THE ENSTROM HELICOPTER CORPORATION
TWIN COUNTY AIRPORT, P.O. BOX 490, MENOMINEE, MICHIGAN 49858

SERVICE INFORMATION LETTER

SERVICE LETTER NO. 0043

Subject: Inspection of 28-16192 and 28-16339 Push-Pull Control Rods

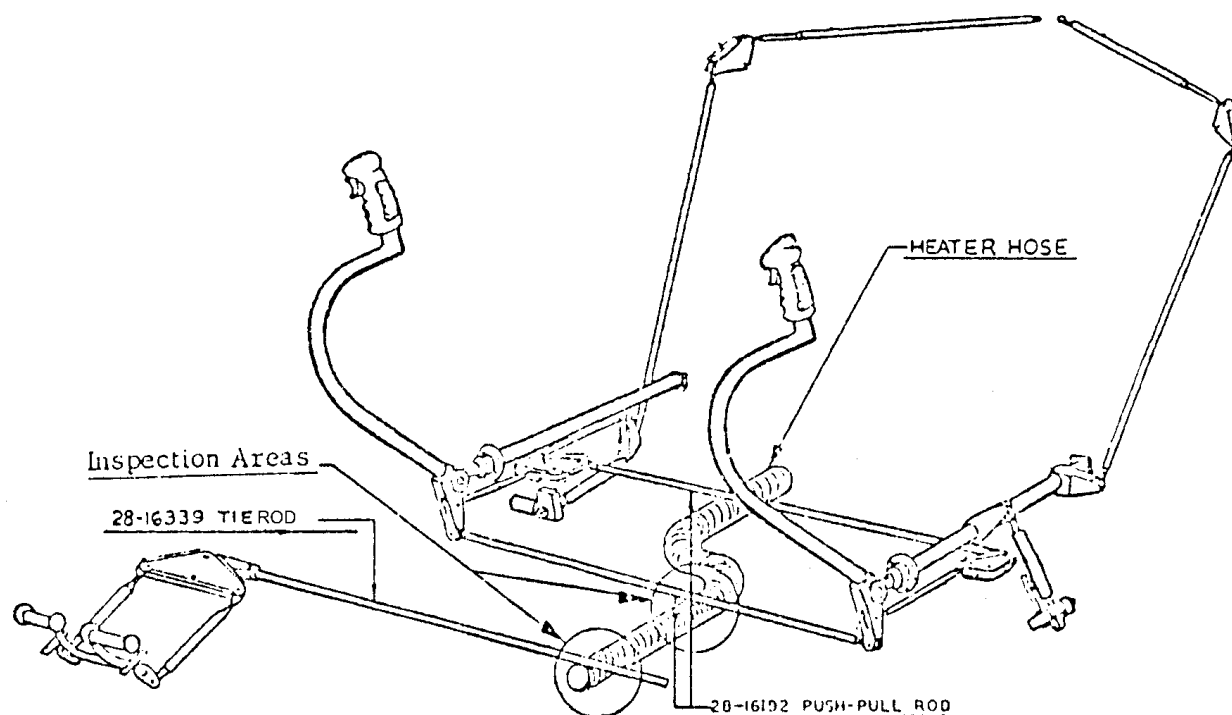
Three instances have been reported of chafing between the forward heating hose and the 28-16192 and 28-16339 push-pull control rods. The inspection areas are illustrated below.

Any wear on the aluminum control rods exceeding .015 depth should warrant replacement. Extra clamping may be required to obtain clearance between the heater hose and the push-pull control rods. Normal clearance is about .38 in.
